ADDENDUM NO. 1

**Administration Building Renovation Re-bid
Compton Community College District**

tBP Project. No. 20987.00

tBP/ARCHITECTURE

drawing no.:
PD-1
drawing of

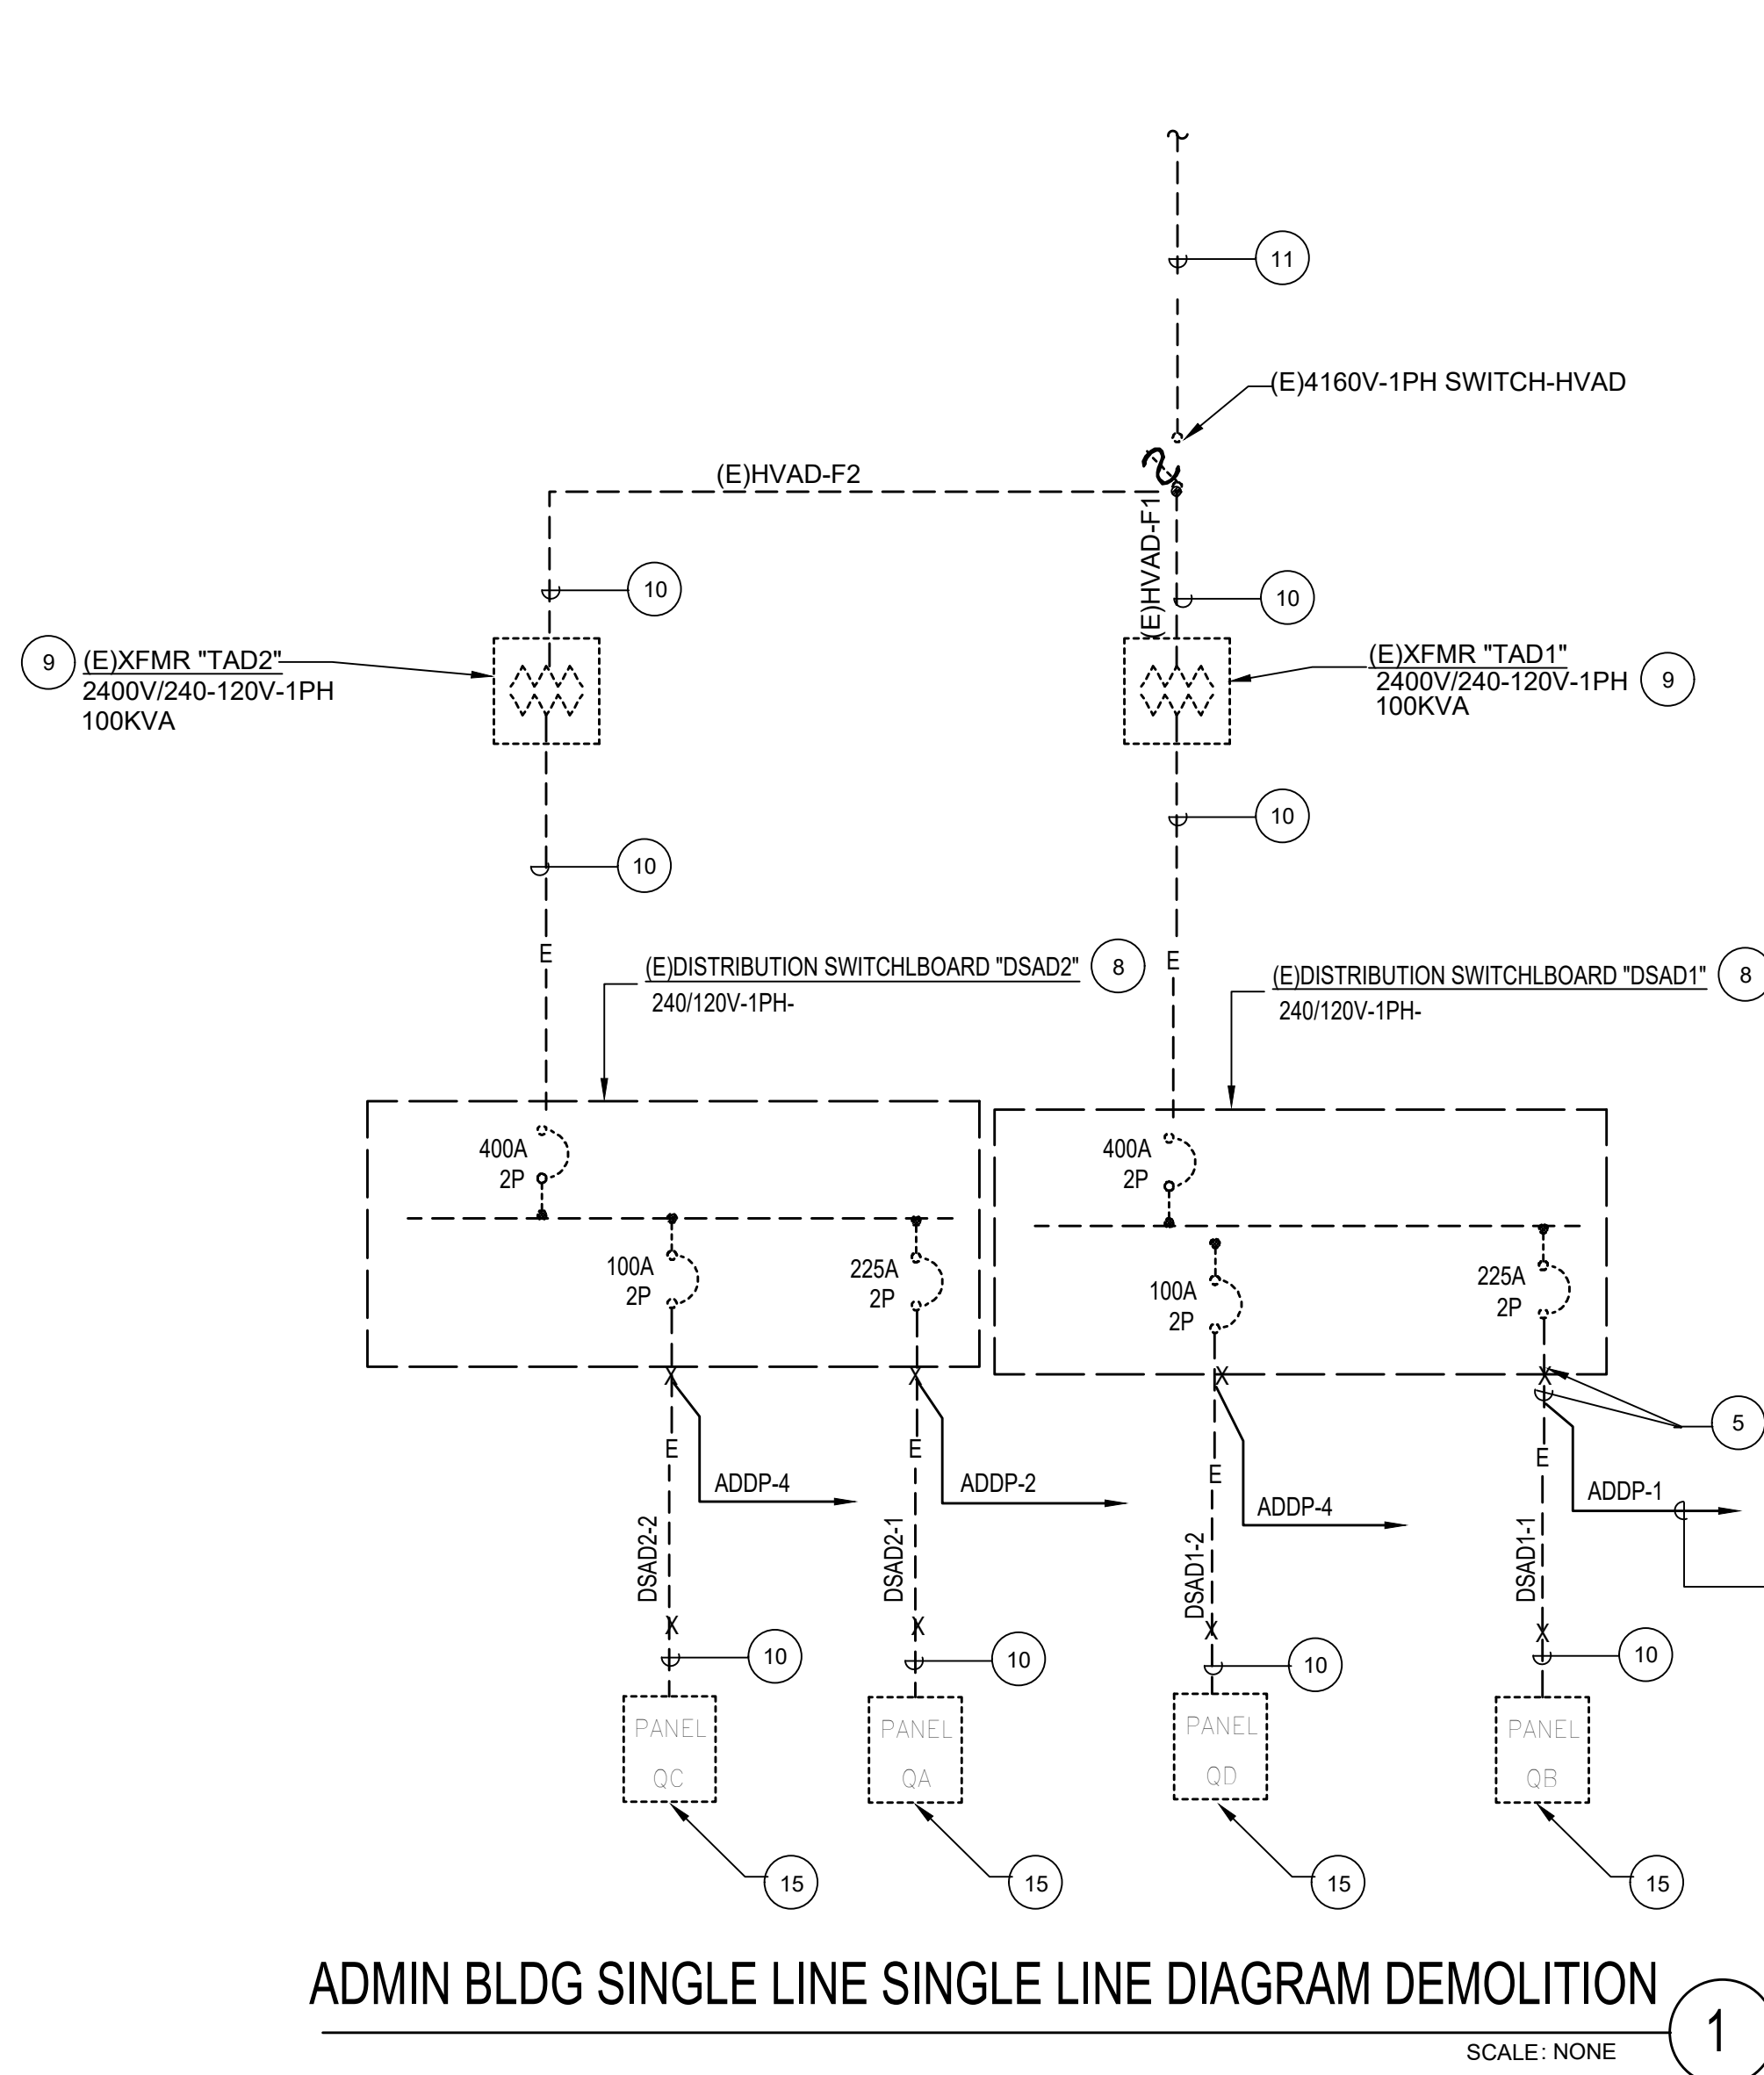
- 22 **Revised Sheet PD1 PLUMBING DEMO PLANS**
- a. Added note to demo existing drinking fountain.
 - b. Added note to demo existing sink.
See attached revised Full size sheet identifying revisions included as part of this addendum.

ADMIN BLDG SINGLE LINE SINGLE LINE DIAGRAM DEMOLITION

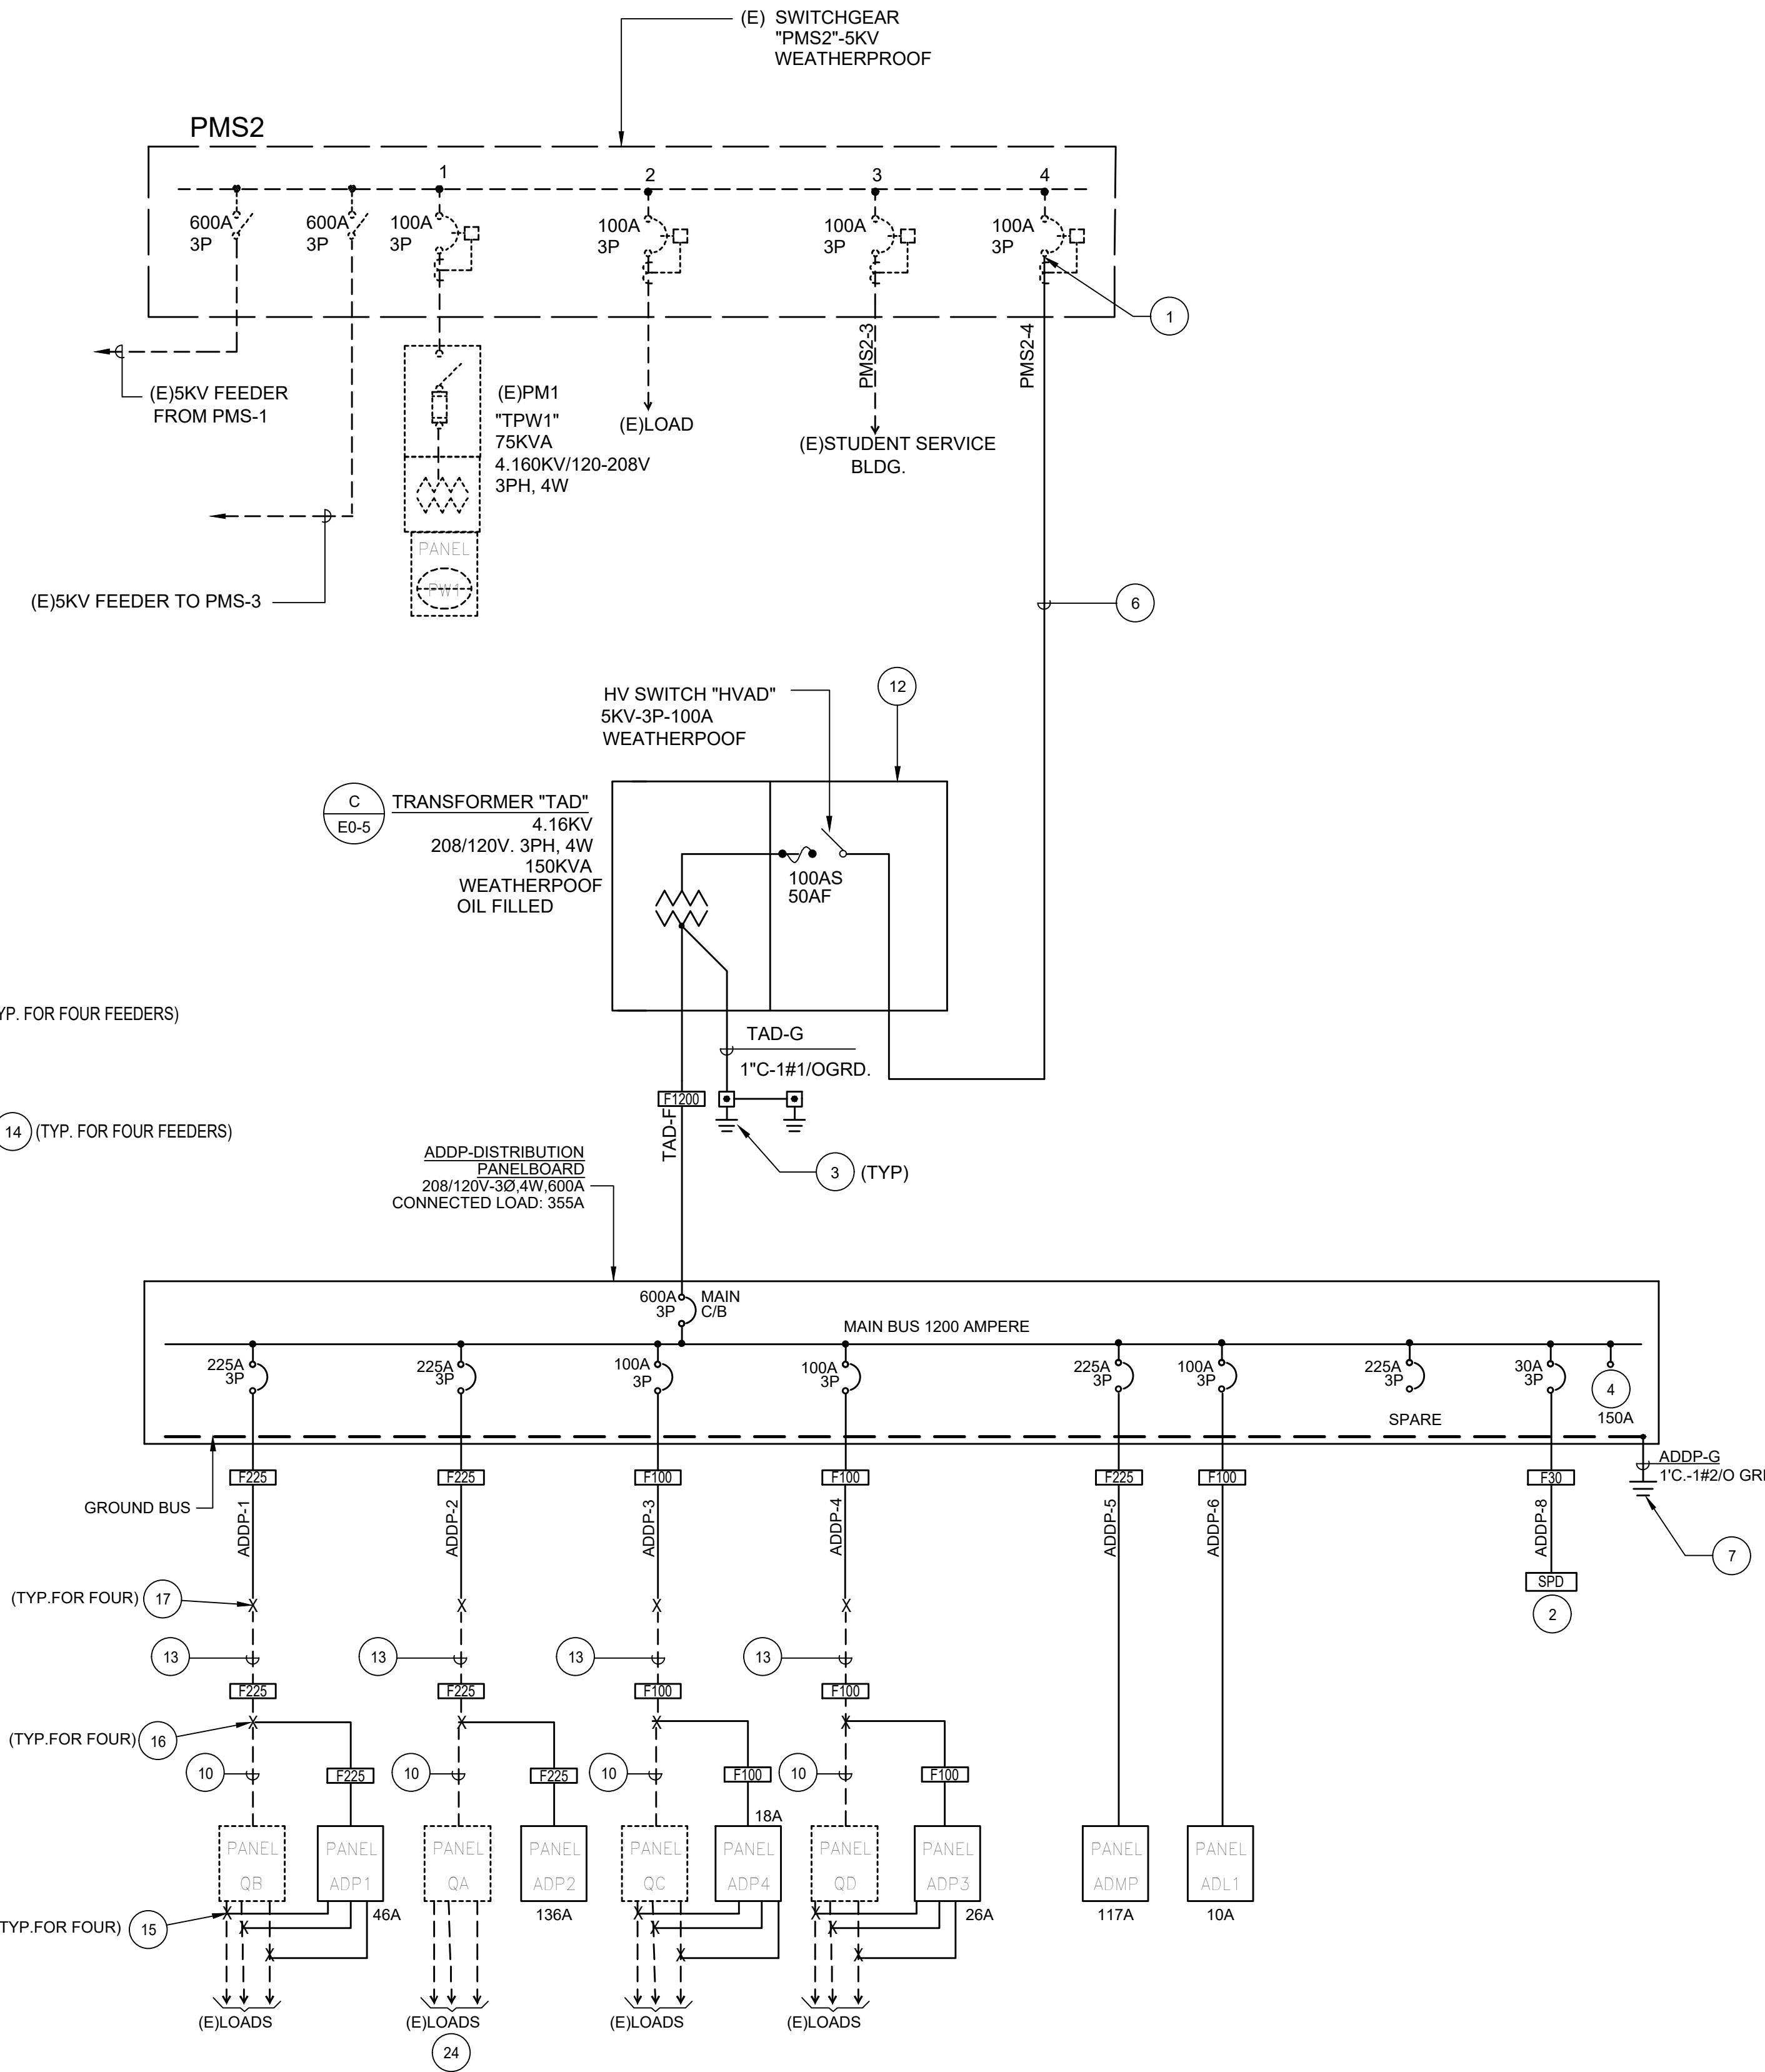
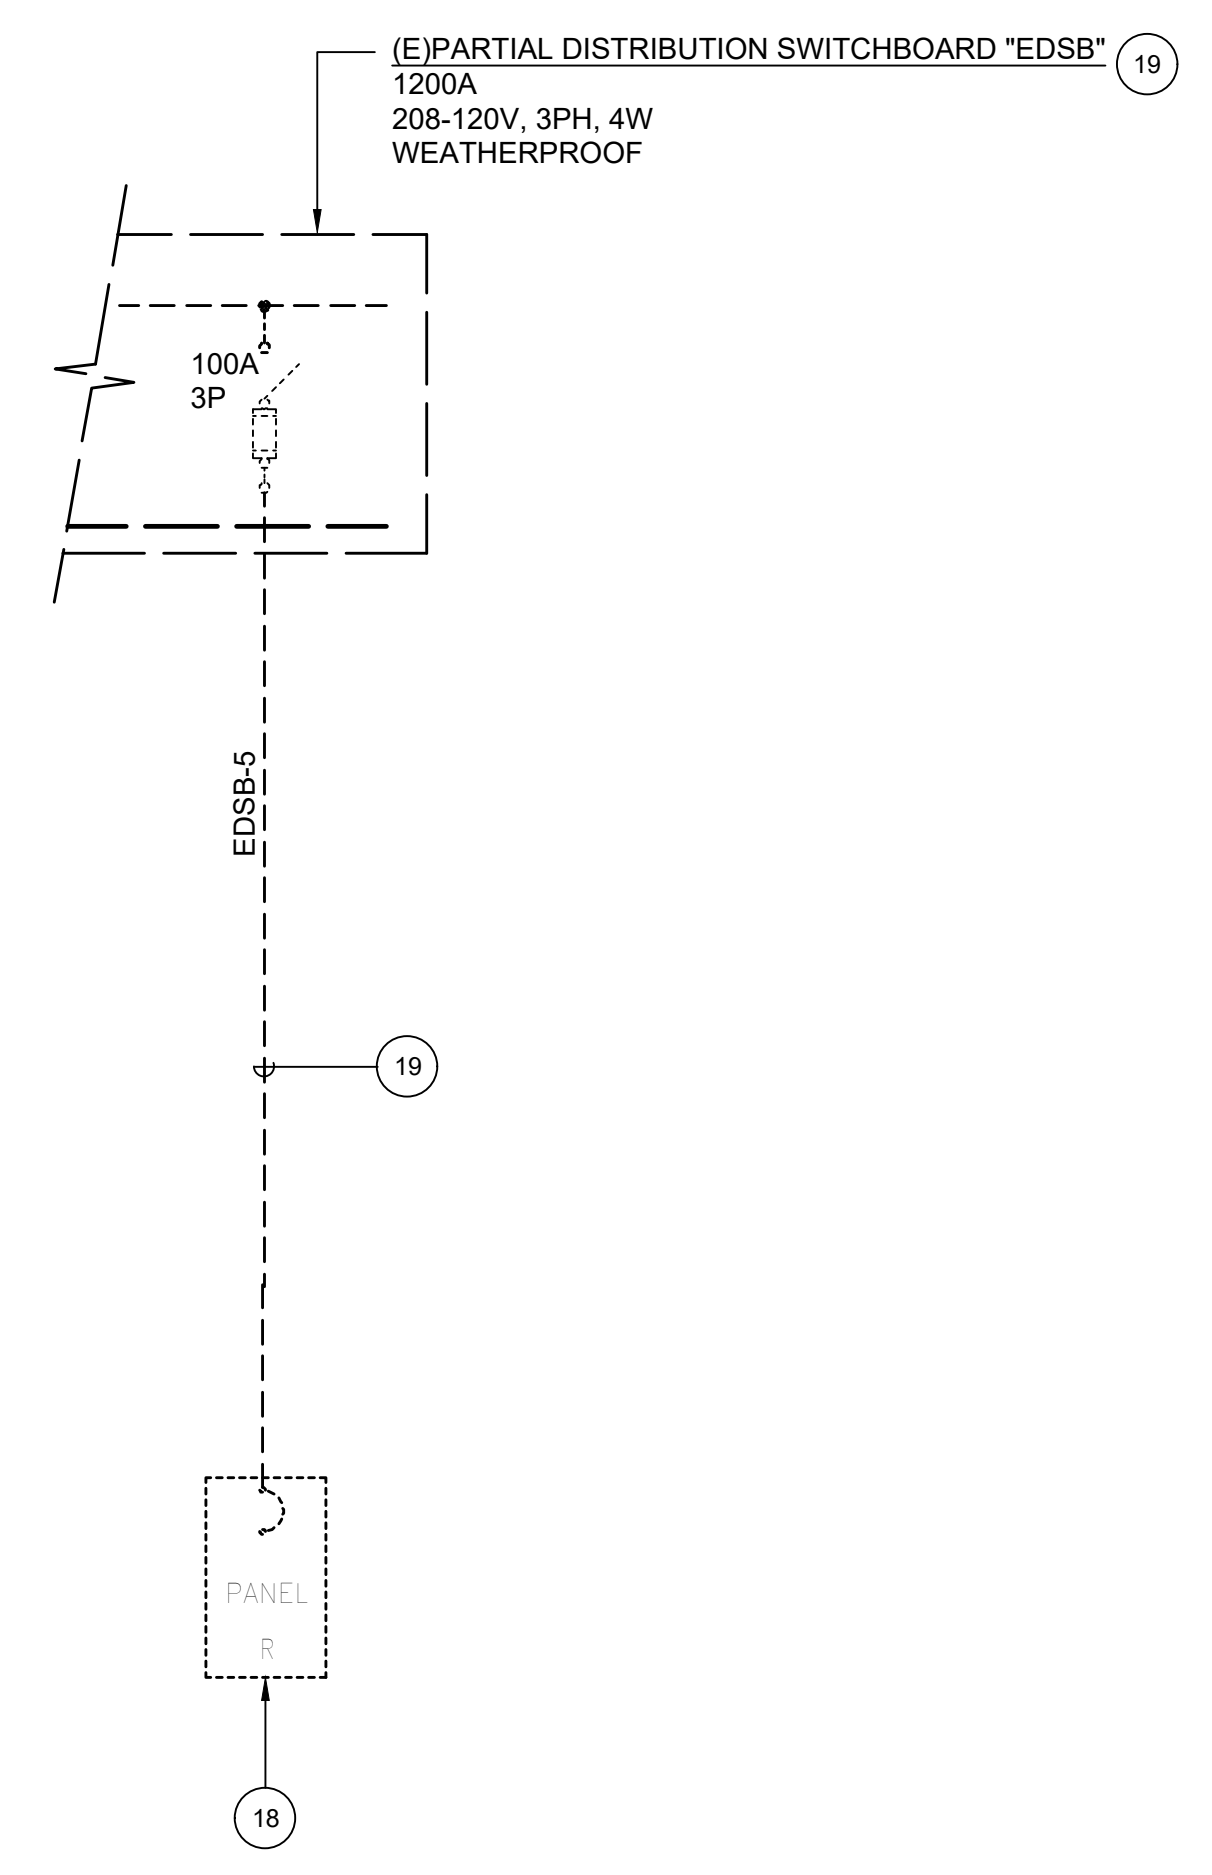
23. **Revised Sheet E0-2 Single Line Diagram in its entirety.**
- a. Included removal of power from student service electrical room.
 - b. Included addition of power from existing 4160V, PMS2 switch to new switchboard.
